**CITY OF UNALASKA**  
**Aquatics Center Improvements**  
**Project No. 15101**

**ADDENDUM TO THE CONTRACT**

Addendum No:	1	Current Bid Opening Date: January 20, 2016 at 2:00 P.M.
Pages This Addendum:	3 Total	
Previous Addenda:	NONE	Previous Bid Opening Date: January 20, 2016 at 2:00 P.M.

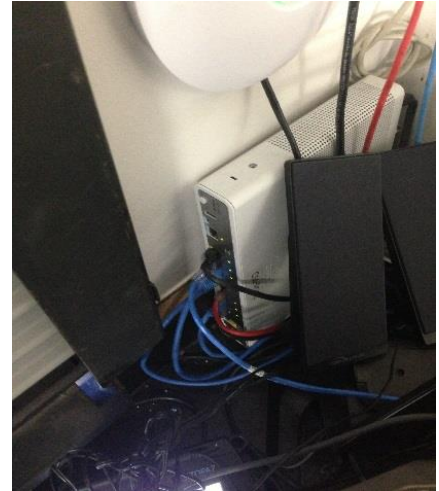
**Question 2:** Where is the current Comm. Room? We are moving the New Comm room to the 2<sup>nd</sup> floor and I see that but where and what all needs to be moved from the old to the new? Also, I see nothing that talks about the Utility cable coming into the Bldg. If this entrance point needs to be moved I assume the utility will do that however, if it is staying and the lines need to be extended into the new TR we need clarification as to what is there and again, where it is going from/to.

**Response 2:**

- a.) All equipment in the new telecomm room is to be provided and installed by the owner.
- b.) There currently is not a telecomm room serving the pool area. Telecommunication cabling comes from the wireless radio on the outside of the building into the Pool Office where it terminates into a Cisco switch, as shown in picture.
- c.) Reference sheet note 12 on sheet E1.1 for removal of the incoming telecommunication cabling.
- d.) Reference sheet note 14 on sheet E3.1 for new telecommunication cabling to be installed the existing wireless radio on the outside of the building to the new 2<sup>nd</sup> floor telecomm room.
